802.1Qau Draft 1.3 issues

Norman Finn

P802.1Qqu Draft 1.3

CN Domain protection problems

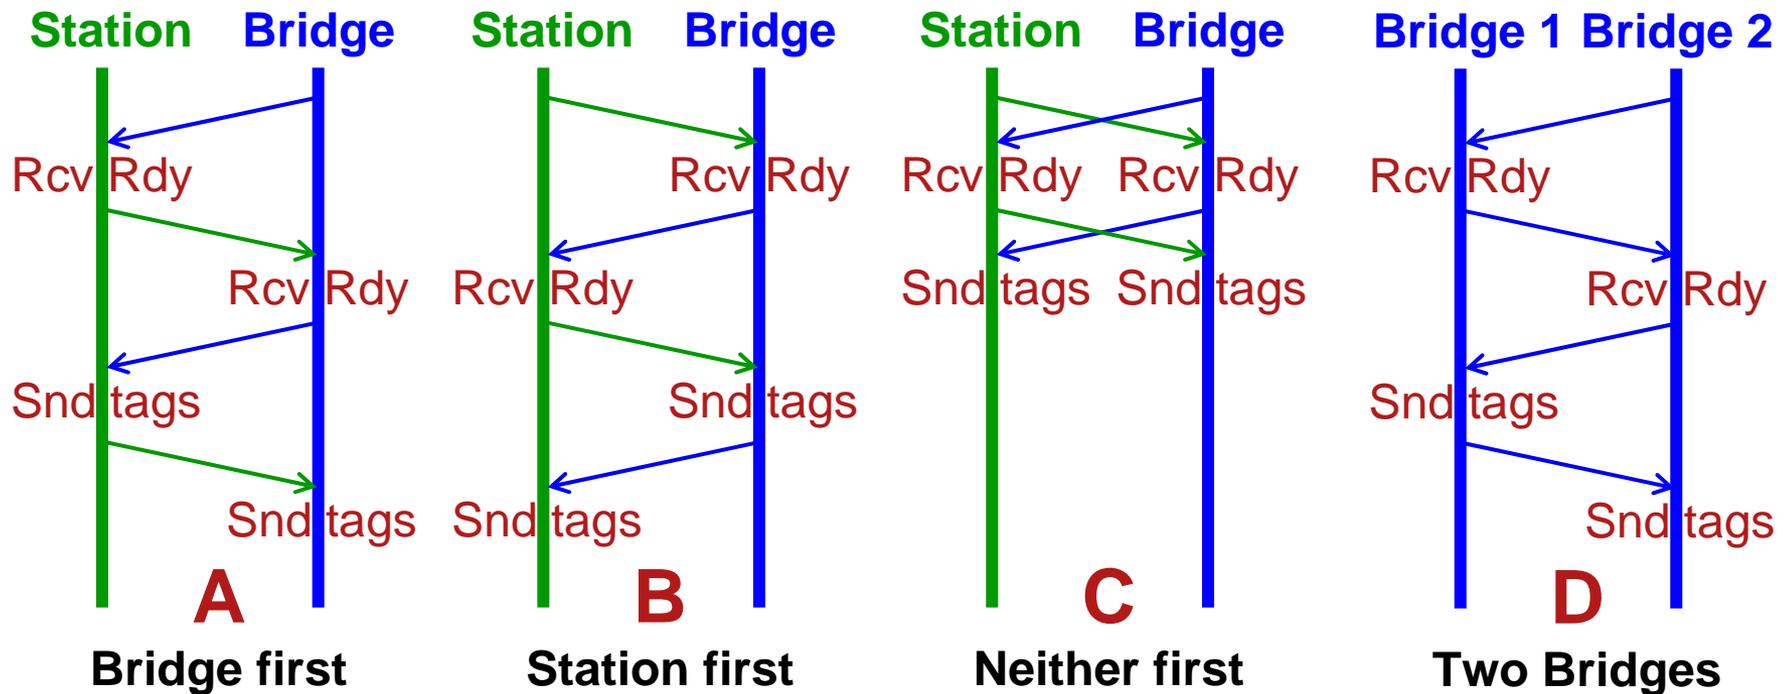
1. Rcv Rdy

- a. Bridge does not want to admit non-CN-aware traffic to a CN Priority, because it will subvert the ability of the network's Congestion Points to throttle traffic.
- b. Station may not want to admit non-CN-aware traffic to its CN-aware queues.

2. Snd tags

- a. Bridge does not want to transmit CN-tagged traffic to a non-CN aware station or network.
- b. End station does not want its CN-aware applications to consider that the link is up unless the neighboring device is CN-aware and compatibly configured.

CND Protection 1: Full handshake

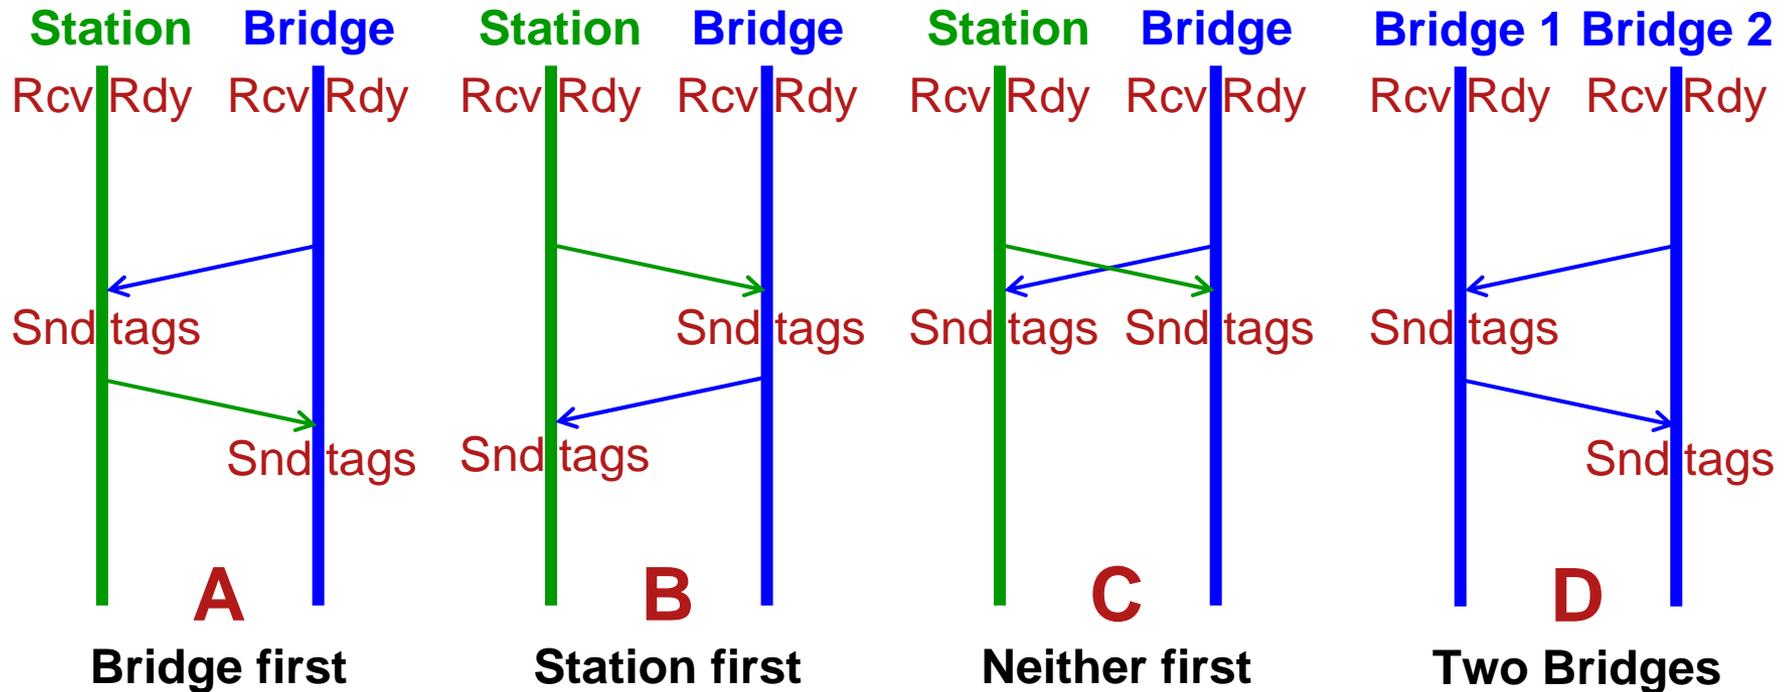
- If the bridge's (and station's) **only method** for protecting the network (queues) is to **remap all incoming traffic** from a CN Priority to a non-CN priority, then this method ensures that the Rcv Rdy problem is solved.
- Solving the bridges' **Snd tags** problem requires that a bridge be able to remove CN-tags on output.
- This technique supports optional CN-tags.

CND Protection **2**: Half handshake

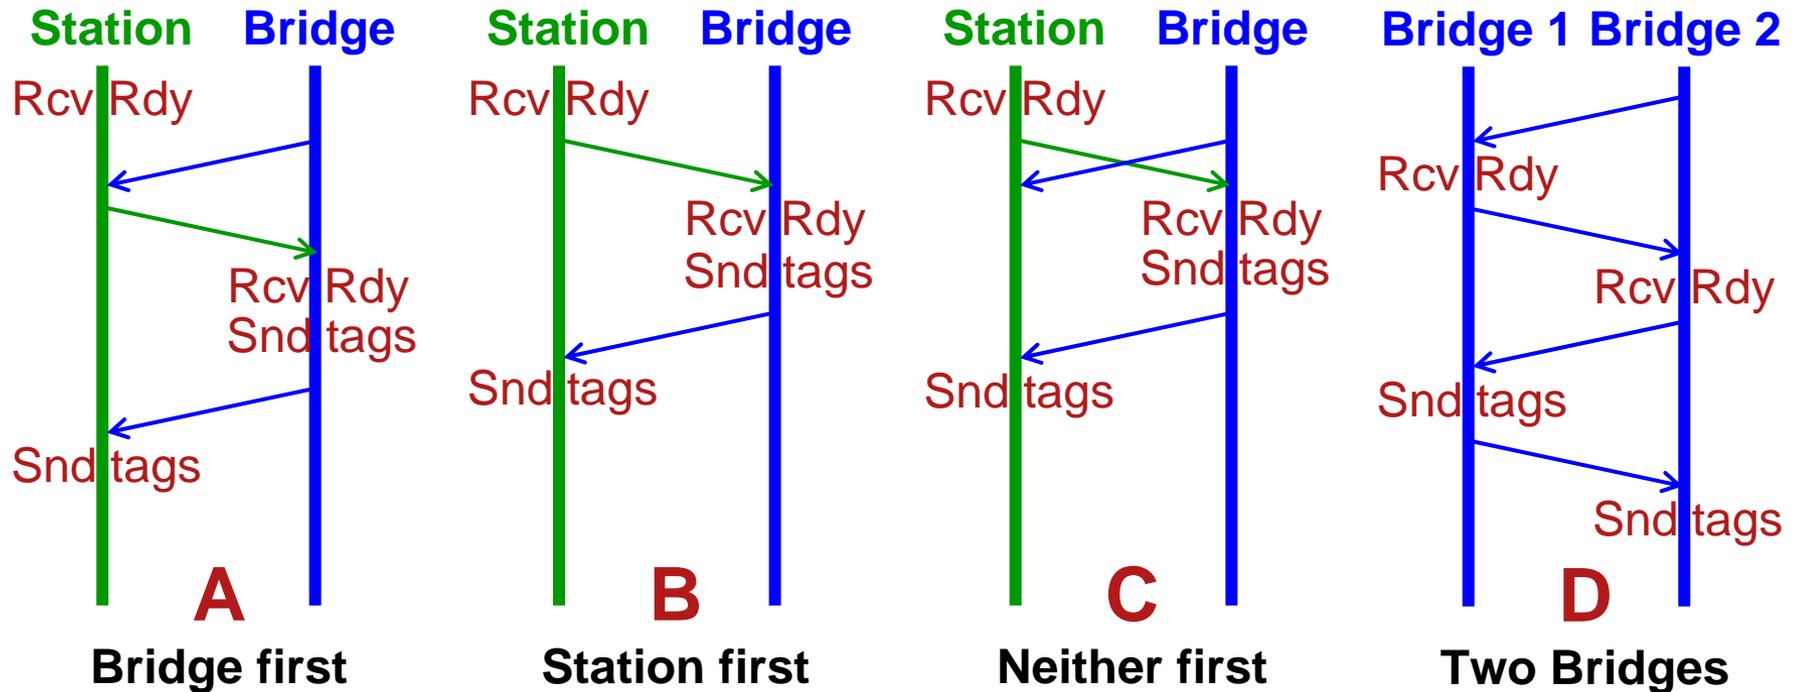
- If the bridge (and station) can:
 - Admit only CN-tagged traffic to a CN Priority; and
 - Deflect non-CN-tagged traffic received on a CN Priority to a non-CN Priority **and remove the CN-tag**.And, if the **CN-tag** is **required**, not optional.
- Then the Bridge and Station can start off in the Rcv Rdy state.
 - They are making the (safe) assumption that CN-tagged traffic is only sent by CN-aware systems.
- This is a quicker handshake, but requires an extra element, an **“Ingress CN-tag checker,”** in the bridge.
